# ADDENDUM

Project Name: Project Name Additions & Renovations–Phase 1 Addendum No.: **Two (2)**  
 Owner’s Name: Klondike I.S.D. Date: March 9, 2009  
 Street Address: 2911 County Rd H Project No.: 07098  
 Lamesa, Texas 79331-4967

## SUPPLEMENTAL DRAWING NO. SD-6

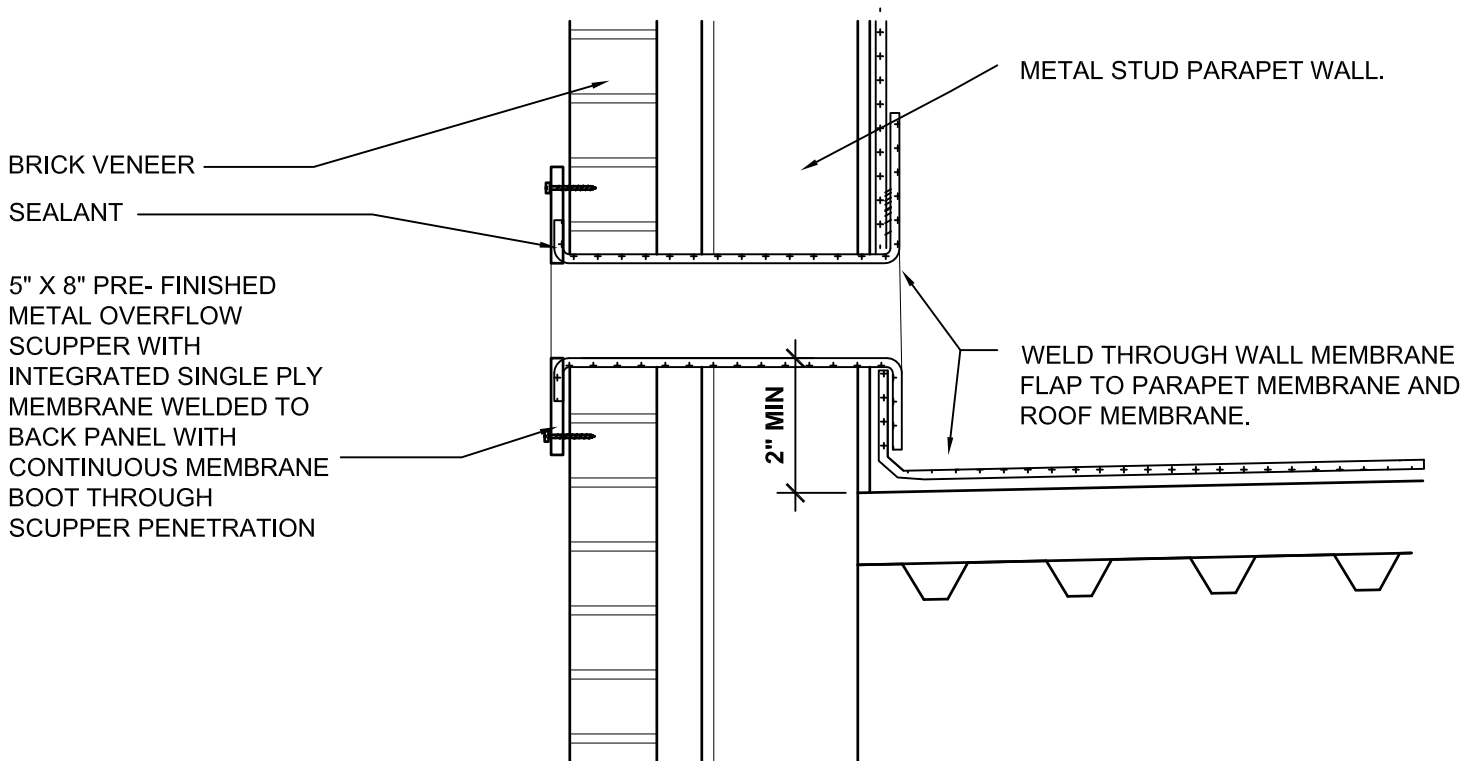
- Item No. One:** In the Drawings, Sheet A6, Building Section 04. See attached SD-6 for roof closure detail at north end of existing shop building.
- Item No. Two:** In the Drawings, Sheet A8, Wall Section 03. Extend durolast roofing up and over existing brick parapet and secure with termination bar on backside of existing parapet. This condition will extend the length of the existing brick building. Remove existing collectors and down spouts and extend durolast into existing scuppers as required.
